<p><b>RME</b> Robitros &amp; Miesia Engineers, Inc. 200 S. Michigan Avenue, Suite 1500, Chicago, IL 60604-2482</p>	<p><b>FGM ARCHITECTS</b> CHICAGO 300 West Jackson Street, Suite 1000 Chicago, IL 60604 www.fgmarchitect.com</p>	<p><b>DRAWING TITLE:</b> PARTIAL ROOF FRAMING PLAN ADDENDUM #1</p>	<p><b>PROJECT NAME:</b> AIR FORCE ACADEMY PHASE II RENOVATION 3630 SOUTH WELLS ST., CHICAGO, IL 60609 CHICAGO PUBLIC SCHOOLS CITY OF CHICAGO, MAJOR RICHARD M. DALEY</p>	<p><b>PROJECT NO.:</b> Rm062410</p>
	<p>DATE: APRIL 27, 2011</p>	<p><b>DRAWN BY:</b> RCW</p>	<p><b>CHECKED BY:</b> EP</p>	<p><b>DRAWING NO.:</b> SSK-01</p>

DETAIL 5/S2.03

ADDENDUM #1

AIR FORCE ACADEMY PHASE II RENOVATION

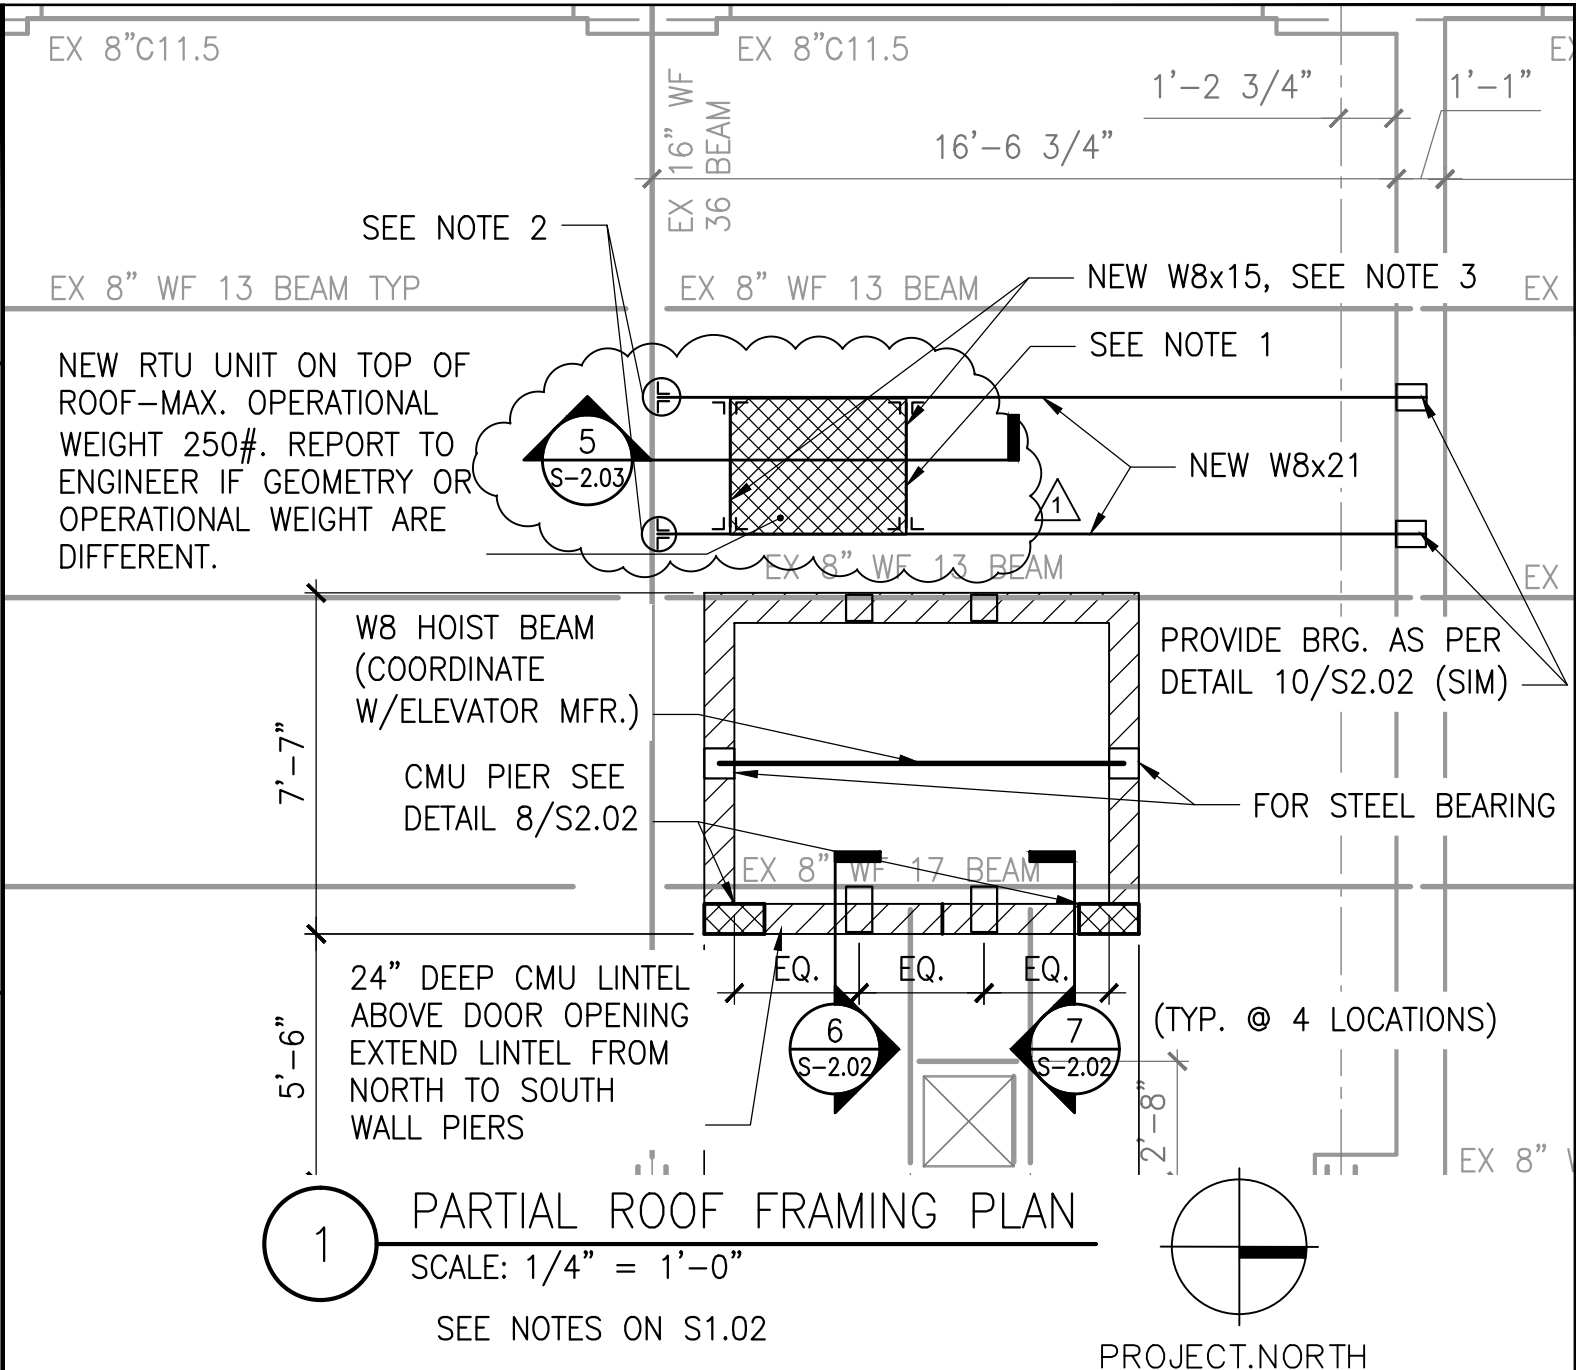
NOTE: LOCATE ADDITIONAL W8'S FRAMING BELOW MECHANICAL CURB

**5** DETAIL  
SCALE: 1" = 1'-0"

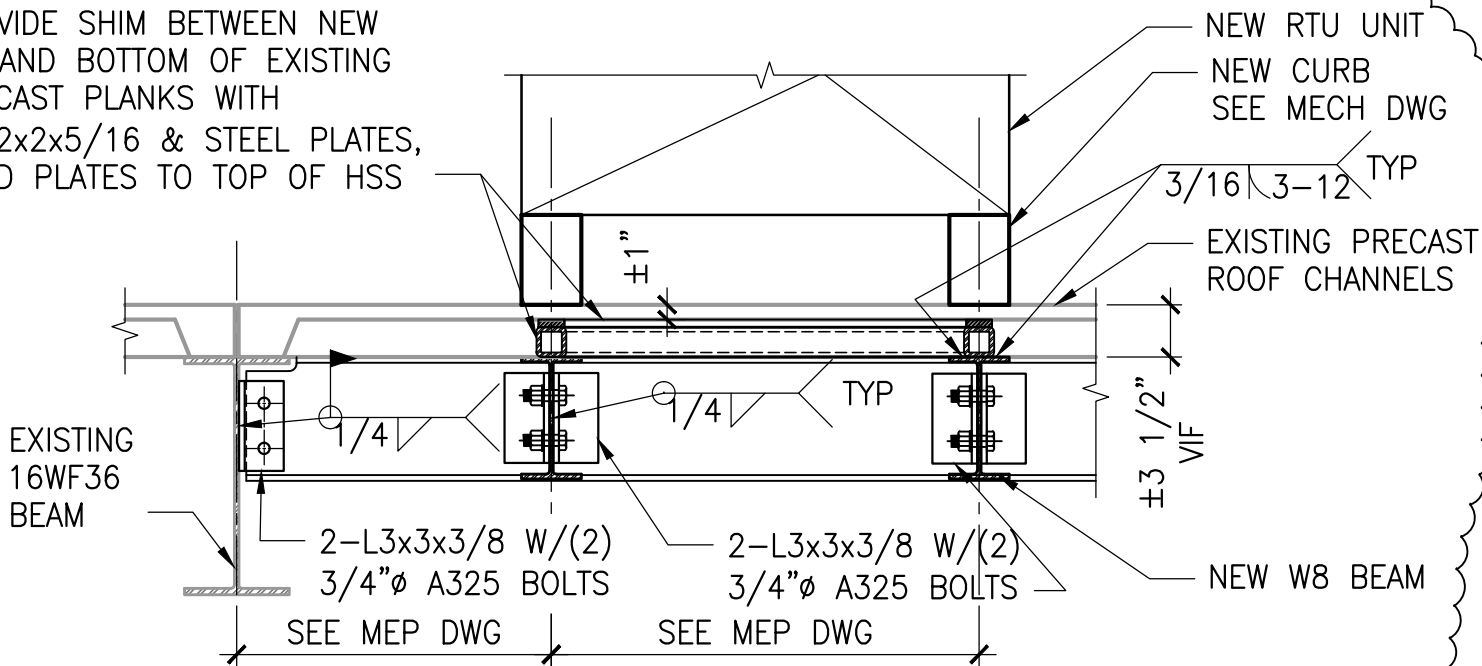
PROVIDE SHIM BETWEEN NEW W8 AND BOTTOM OF EXISTING PRECAST PLANKS WITH HSS2x2x5/16 & STEEL PLATES, WELD PLATES TO TOP OF HSS
